STUDER

STUDER D820 MCH
Modifications
and
Software Update V2.2

SI 154/91 Order No. 10.85.7300 (Ed. 0791)

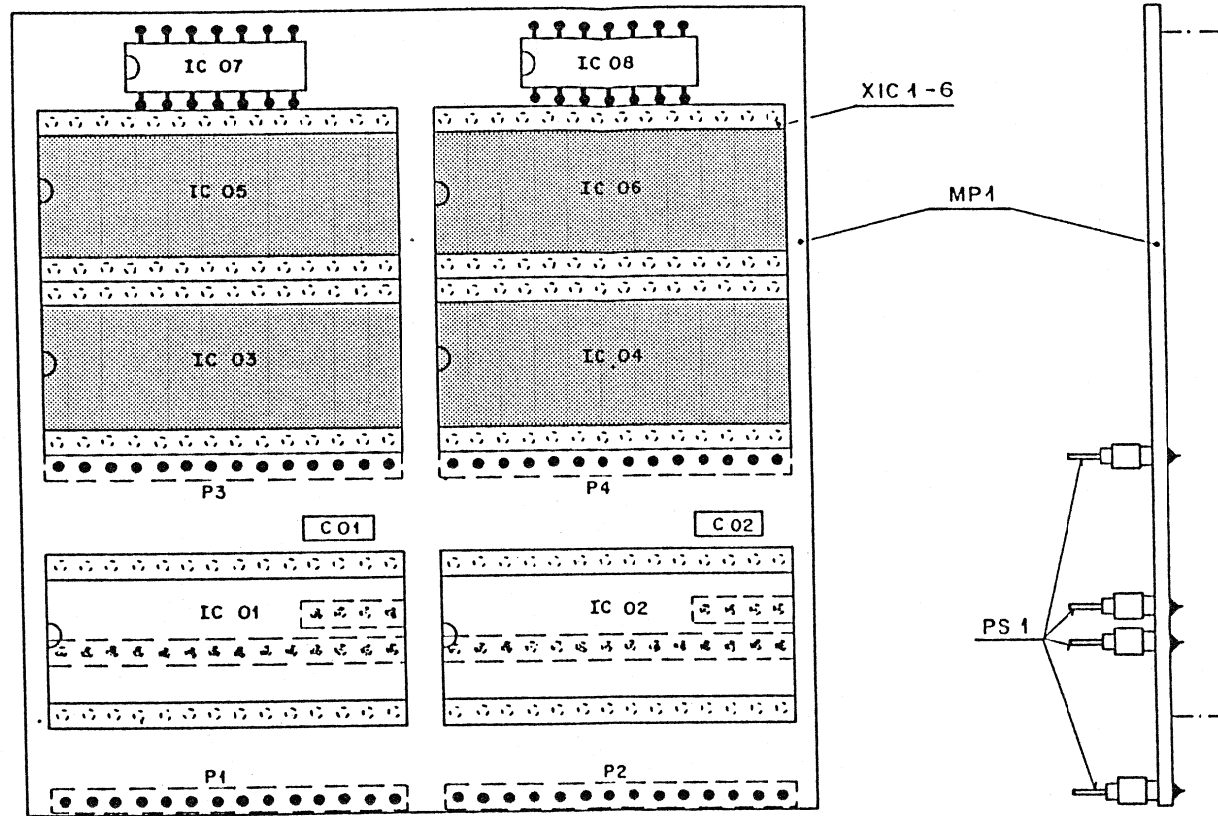
Modification CPU Piggy Back 1.862.686.21

New Master software V2.2 (28/91).

- Replace IC3 - 6 (old software number 1.862.926.21) by new software 1.862.926.22.

Change board index to new 1.862.686.22 .

Change also board index of CPU Force to new 1.862.655.22 .

MODIFICATION PIF-BOARD 1.862.656.22

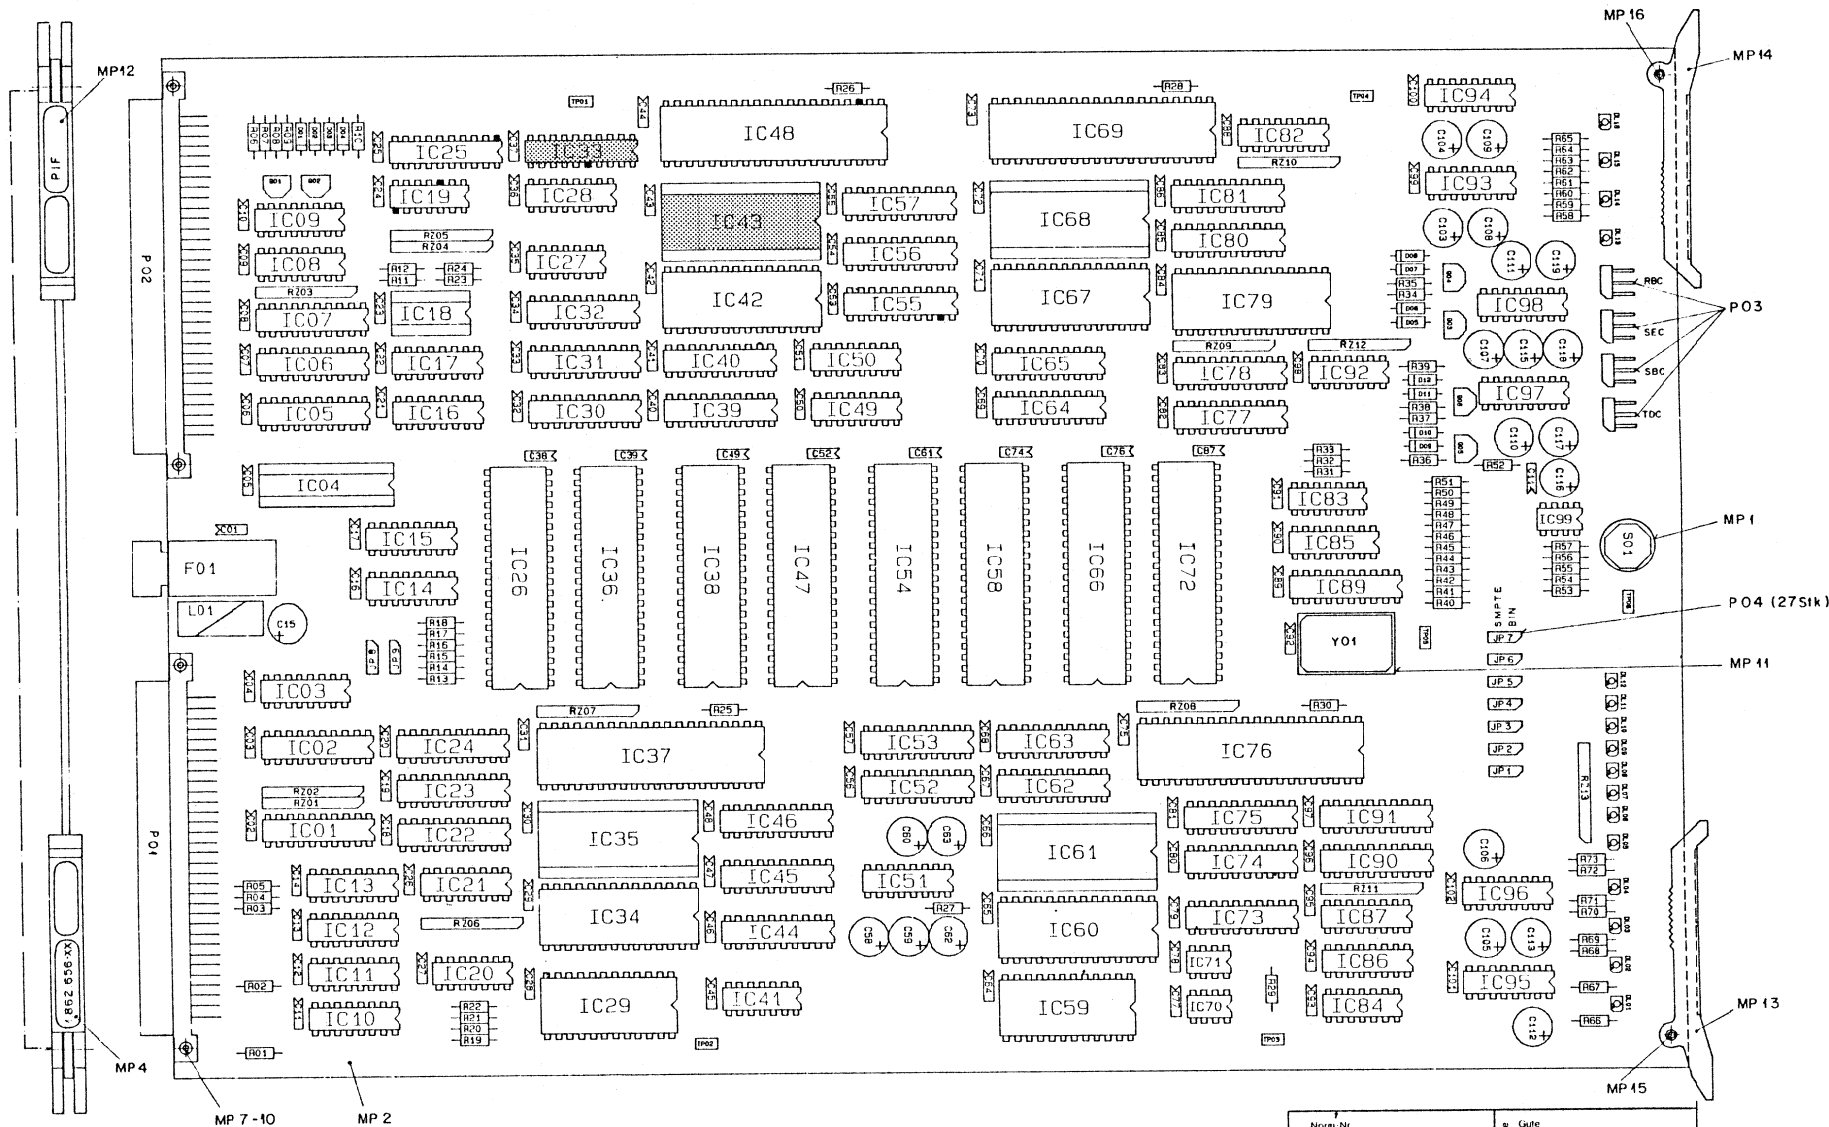
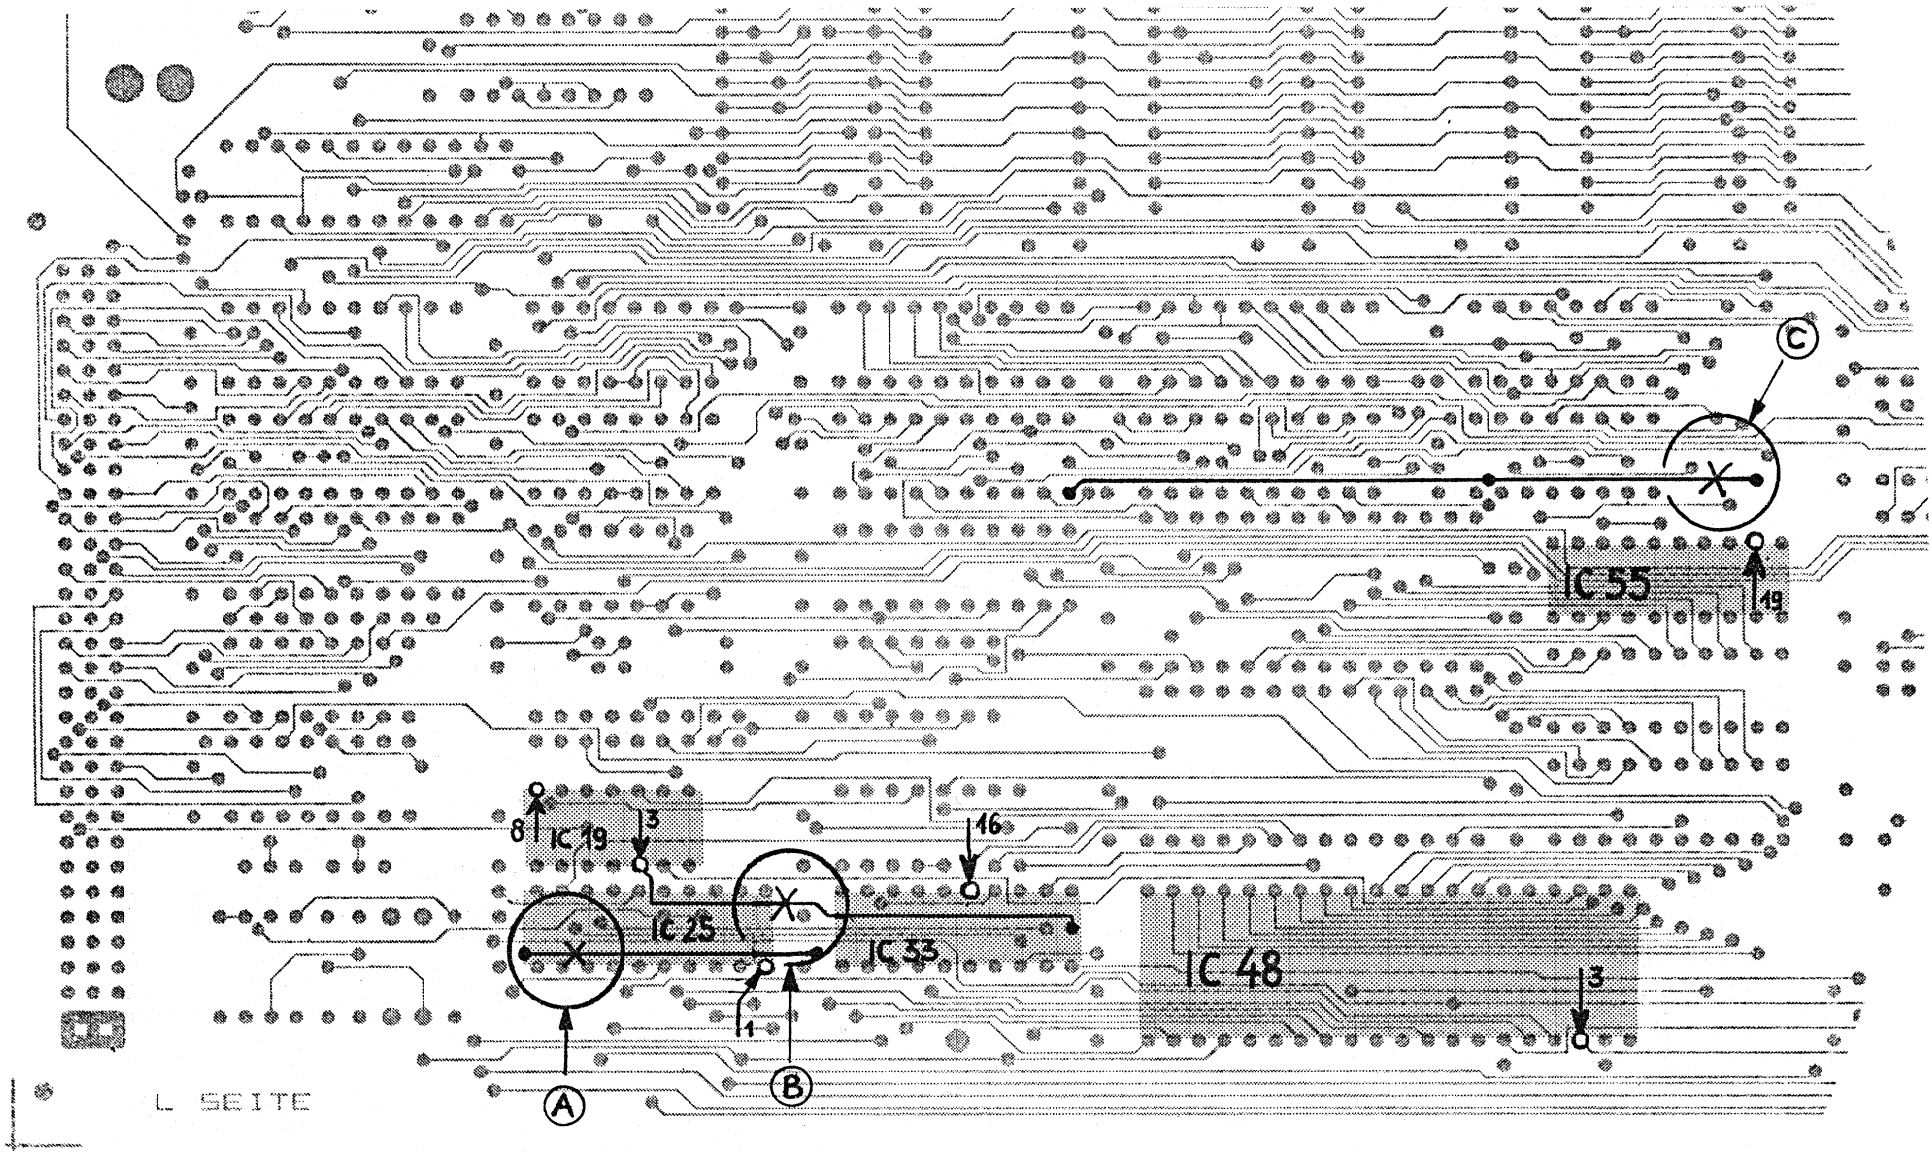
<u>Modification</u>	<u>Peripheral IF</u>	<u>1.862.656.21</u>
---------------------	----------------------	---------------------

- Faulty SERBUS-transmission under several circumstances due to timing problems with new components specifications.
- Implementation of new Master software V2.2 (28/91).

- Replace IC33 (old software number 1.862.932.20) by new software 1.862.932.21.
- Replace IC43 (old software number 1.862.938.21) by new software 1.862.938.22..
- Cut three conducting paths (marked "A", "B" and "C") as indicated on wiring plot.
- Add a wire from IC19, pin 8 to IC55, pin 19.
- Add a wire from IC48, pin 3 to IC19, pin 3.
- Add a wire from IC33, pin 16 to IC25, pin 1.

Change board index to new 1.862.656.22 .

Version DIN Bez. Abmessung	Numm. Nr. DIN Bez. Abmessung	Umfang Quantität Beh.	
Zugfertiger (Mitarbeiter) PL, BV 640	Firmenabteilung Maffstab 4,3:1	Anzahl 28.8.89	28.8.89
Ersatz für	Ersetzt durch	Körper Nr.	
STUDER REGENSDORF ZÜRICH	REFERENCE TRACK ESE	1.862.657-24

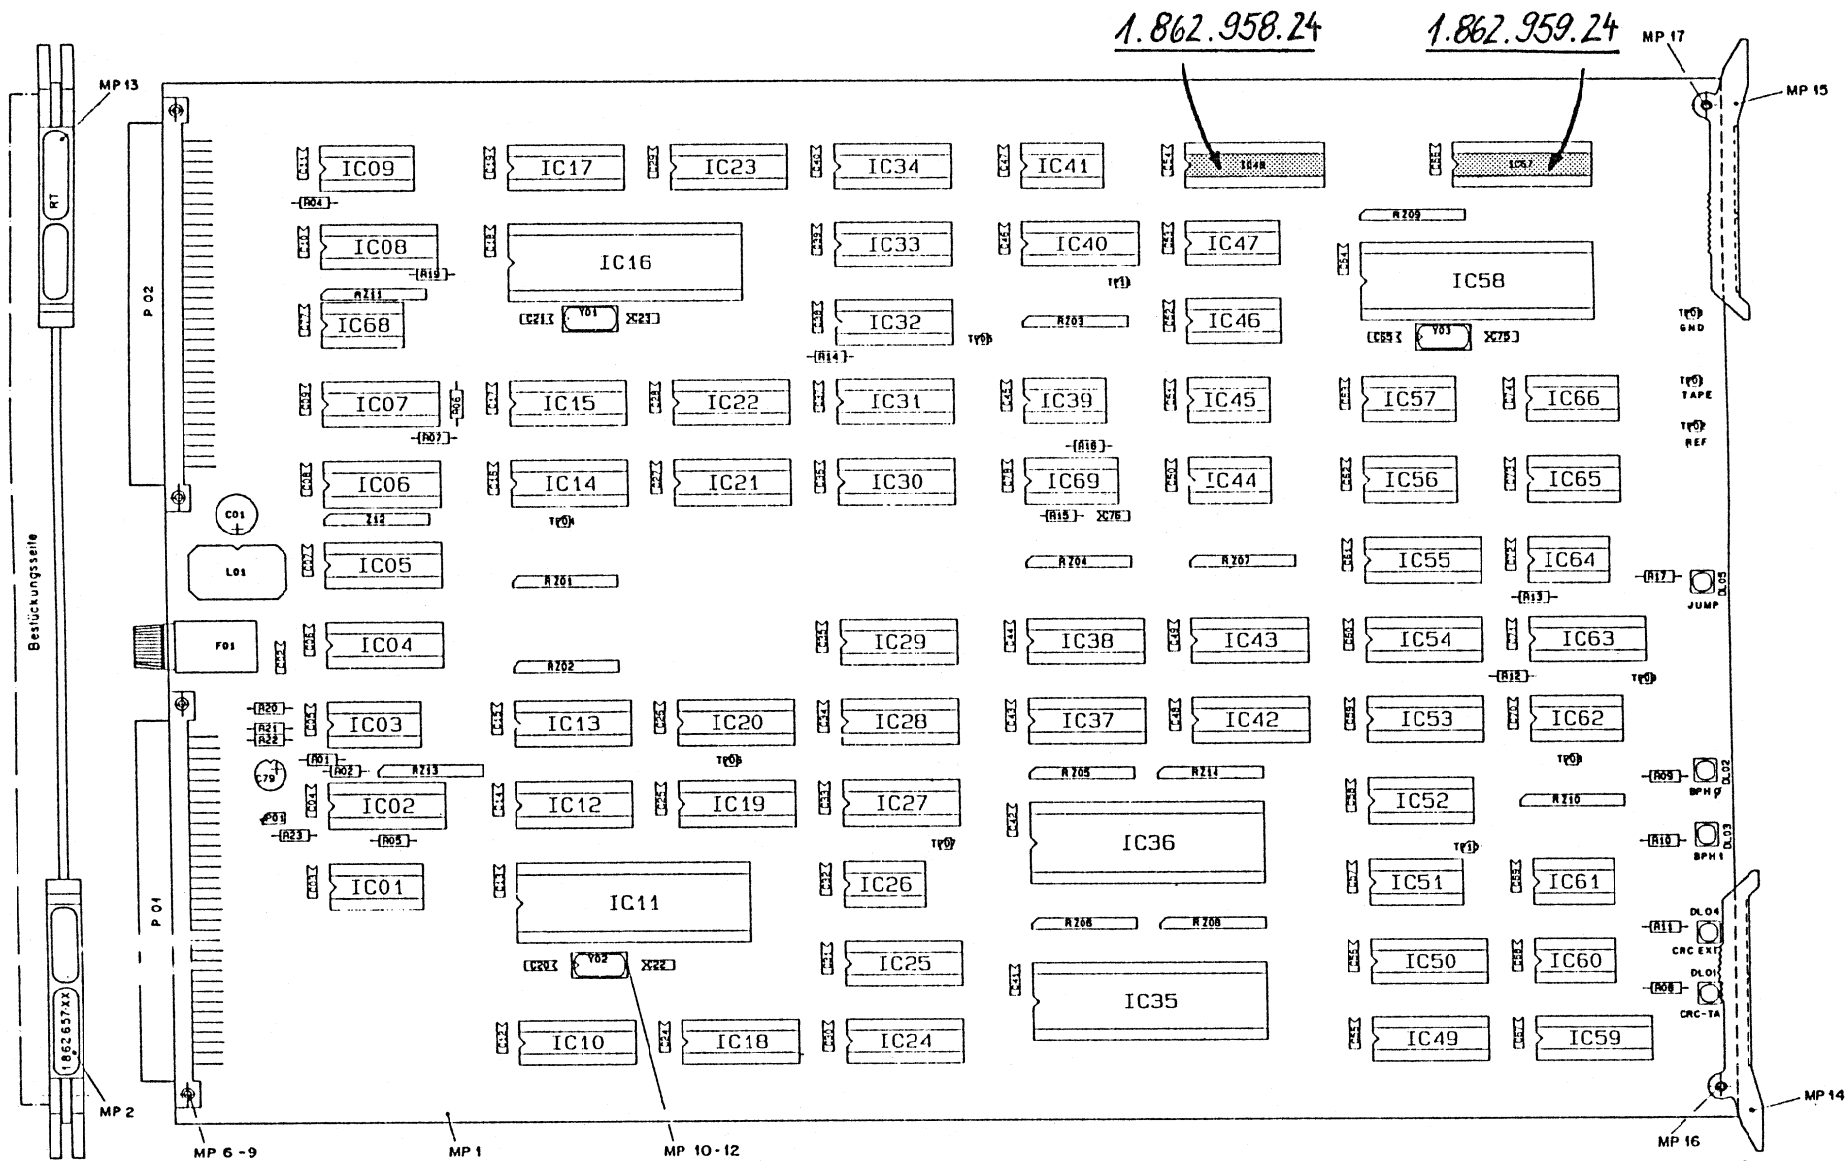
Modification Reference Track Board 1.862.657.23

New Master software V2.2 (28/91).

- Replace IC48 (old software number 1.862.958.23) by new software 1.862.958.24.
- Replace IC67 (old software number 1.862.959.23) by new software 1.862.959.24.

Change board index to new 1.862.657.24 .

SOUND MEMORY 1.862.665.21

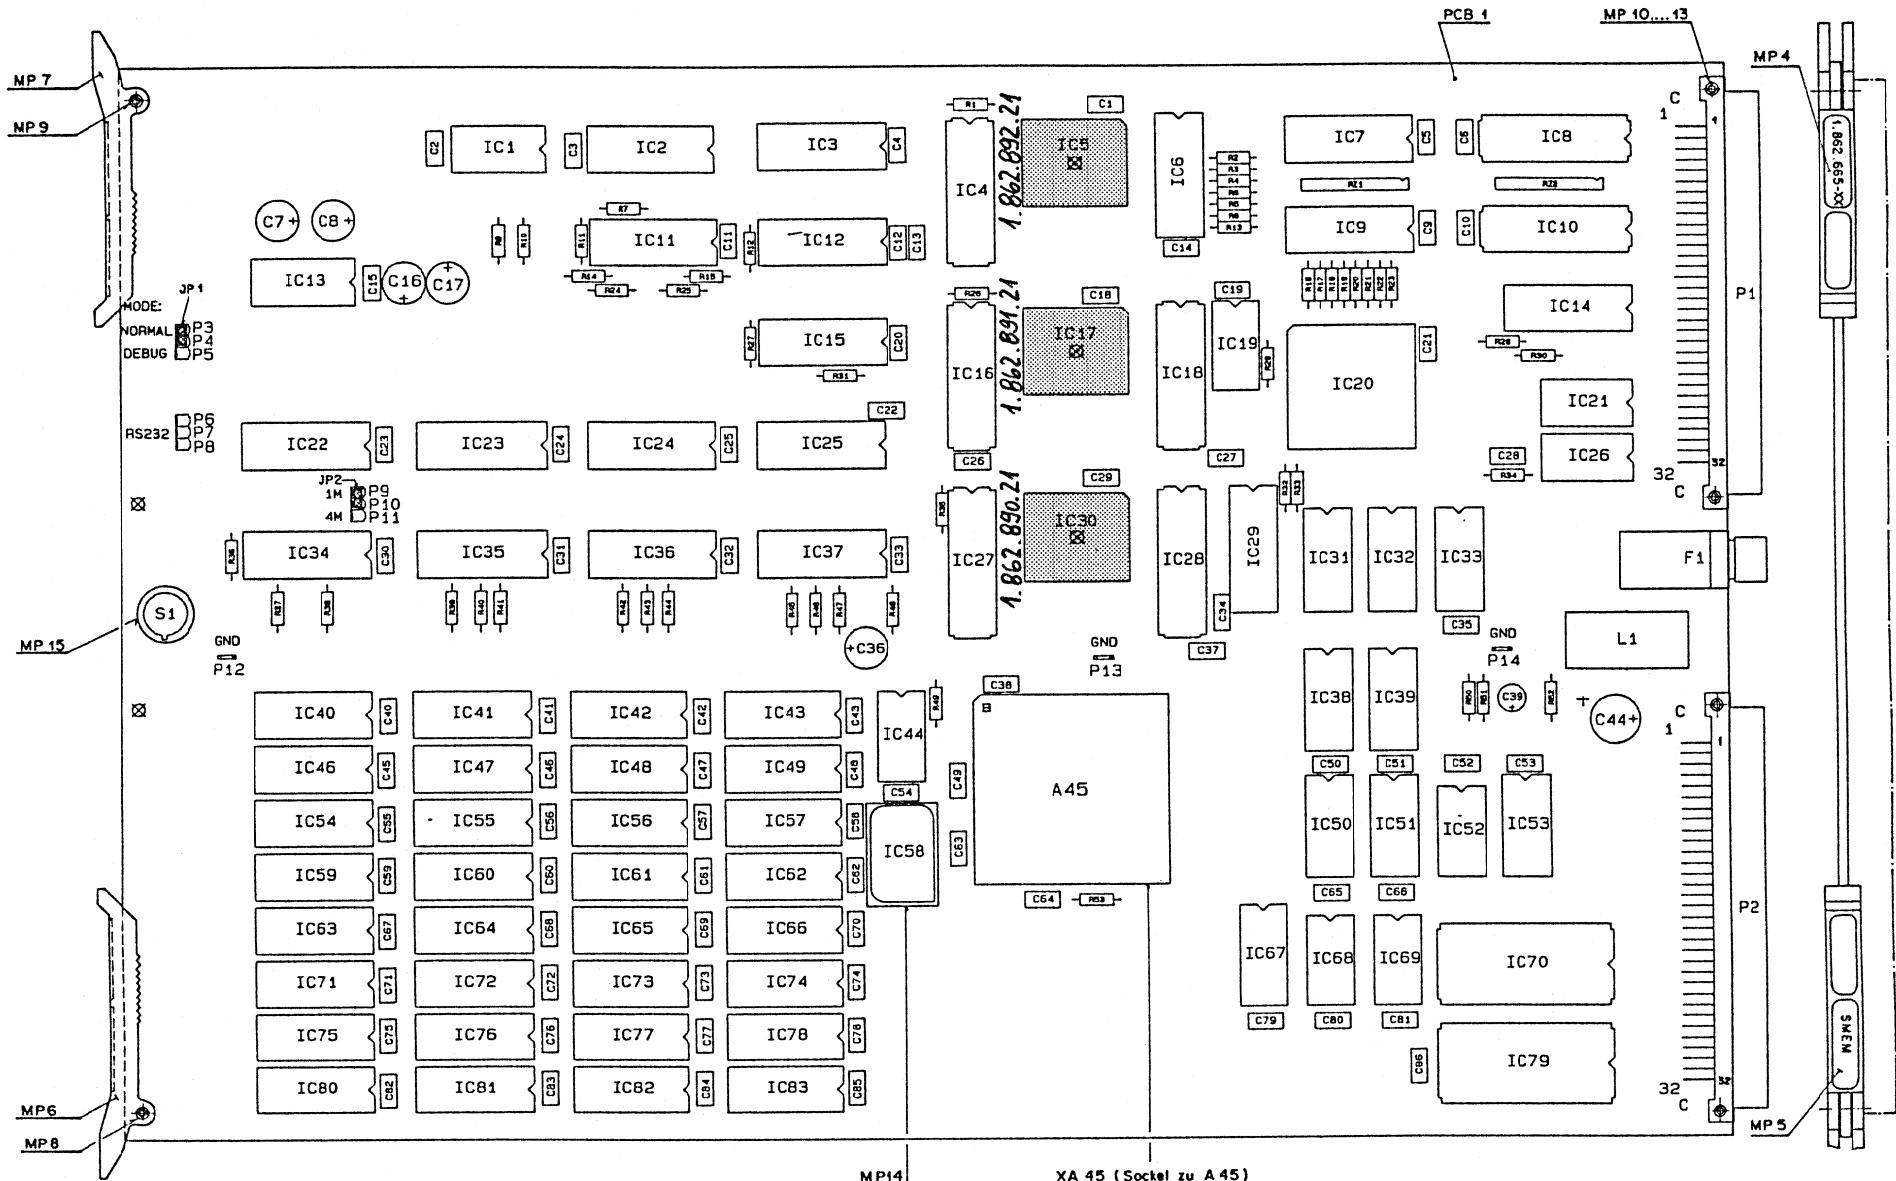
Modification Sound Memory 1.862.665.20

New Master software V2.2 (28/91).

- Replace IC05 (old software number 1.862.892.20) by new software 1.862.892.21.
- Replace IC17 (old software number 1.862.891.20) by new software 1.862.891.21.
- Replace IC30 (old software number 1.862.890.20) by new software 1.862.890.21.

Change board index to new 1.862.665.21 .
